\* Legend J2 Rev.: no "IC17", BOARD MODIFICATIONS for 64KZ REV Solder side: J1  
 but "20 MHz" still present. Legend: J2 Date 6-1-81

ML 2

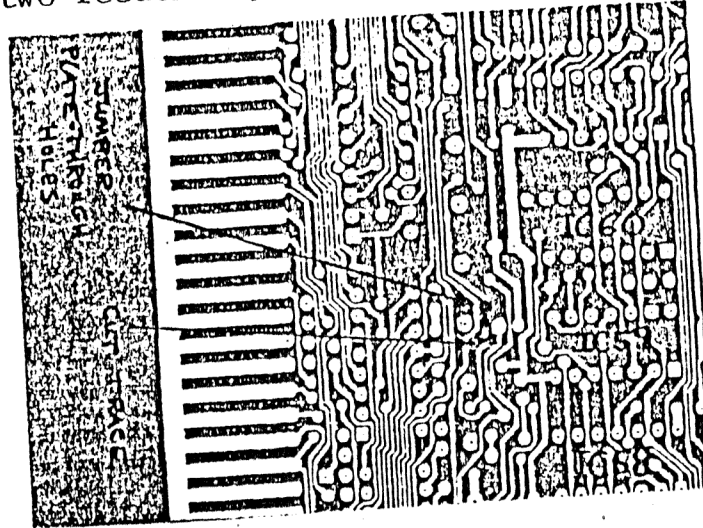
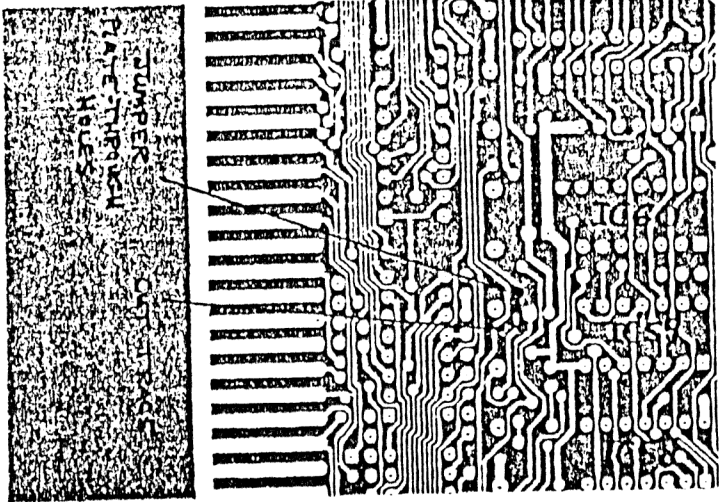
On solder side, cut trace and jump the two feedthrough holes as shown.

This will route sOUT through the de-glitching RC network (RN5 & C69) to IC59-10. Noise on sOUT taken directly off the bus could generate an invalid bank select pulse to IC8-9, causing the system to crash, when writing to memory addresses with lower address of 40H (also the bank select port).
